SB Number:	SB 2C9-033	Creation Date: 12/06/2008
Subject:	Black or white lines due to dust	
Model:	KM-1620/2020/1650/2050/2550

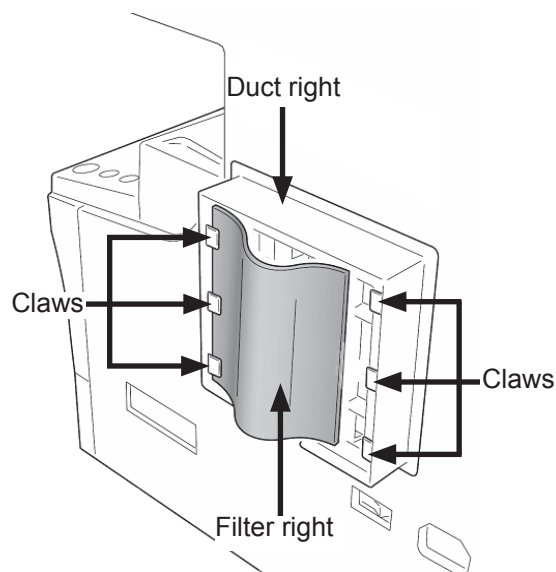
Phenomenon	Black or white stripes may appear on the image.
-------------------	---

Cause	Dust that is sucked in by the right fan may contaminate the main charger/LSU right or slit glass.
--------------	---

Solution	<p>Add Duct right (302C904600) and filter right (302C904610) over the position of the right fan on the outside of the machine, to prevent dust from getting into the machine..</p> <p>See instructions below.</p>
-----------------	---

With the notch of the duct right pointed downwards, hook the 4 claws onto the right side of the machine as indicated.

Install the filter right under the 6 claws of duct right.
